FSN781 00484

December 2018

URGENT - Field Safety Notice Medical Device Correction

Additional fixation (grip) of the ceiling speakers of the MR system

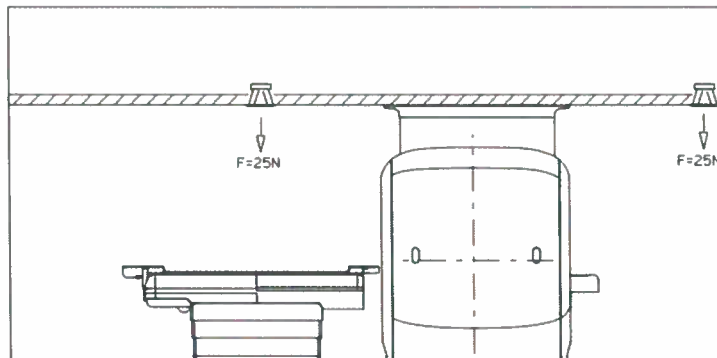
- Following checks/actions by the customer are recommended:
- Check if the speakers are mounted in the ceiling.
 - Visually check for signs of fixation degradation: e.g. water leakage, color changes of ceiling tiles, poorly positioned tiles.
 - In case of suspected insufficient fixation, do not correct the fixation yourself, but immediately contact your local Service/Philips representative.

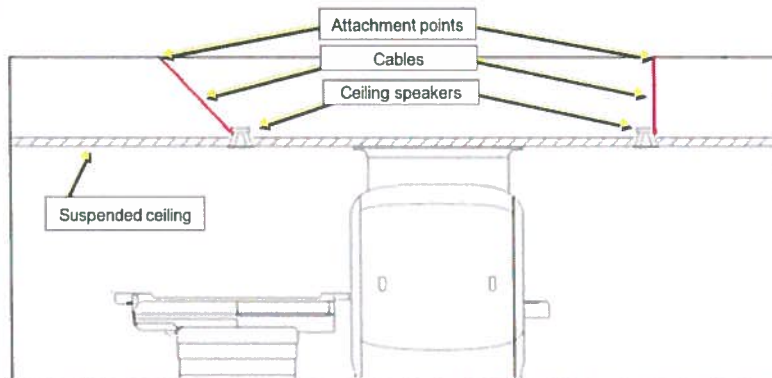
Via FCO78100484 an additional fixation will be installed. This 'non-magnetic' mechanical safety connection will be fixated to the ceiling speaker(s) and anchored to an external fixation point e.g. the ceiling roof, suspended ceiling rods, etc.

FCO78100484, with a required downtime of 0,5 hours, is free of charge. Please contact your local Philips representative, for further details.
